**Logan Todd Regional Water Commission**  
**Water System Expansion to Springfield TN**  
**Contract No. 3 – 24” Water Pipeline to Springfield**

**ADDENDUM No. 4**

April 25, 2018

# CONCRETE THRUST BLOCKS

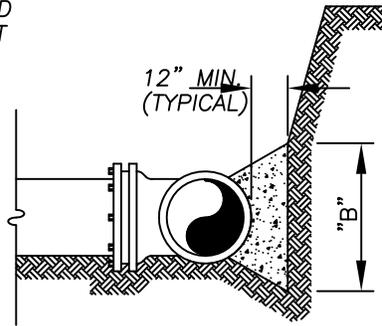
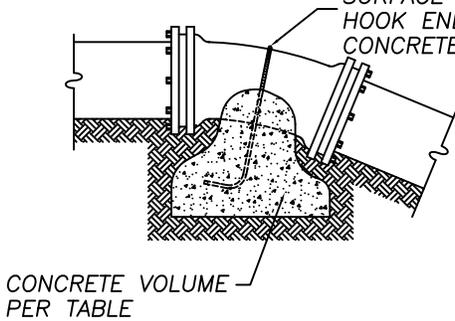
9. Contract Documents: Appendix: **Add** Appendix 8 – Pre-Bid Meeting Attendance List (Attachment: 4 pages).
10. Drawings: Detail Sheet D-1 “Water Line Details”: **Replace** Detail 1 - “Concrete Thrust Blocks” with the attached modified illustration. (Attachments: 1 page)

# WETLAND CROSSING X-SECTION

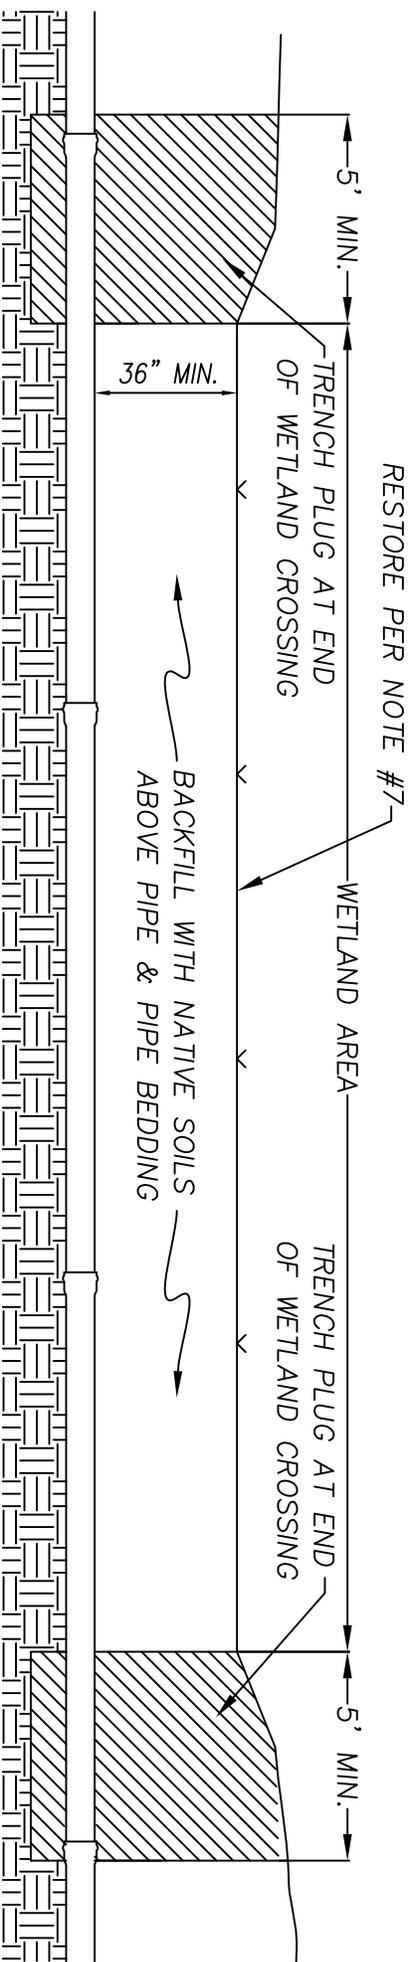
11. Drawings: Detail Sheet D-1 “Water Line Details”: **Replace** Detail 9 - “Wetland Crossing X-Section” with the attached modified illustration. (Attachments: 1 page)
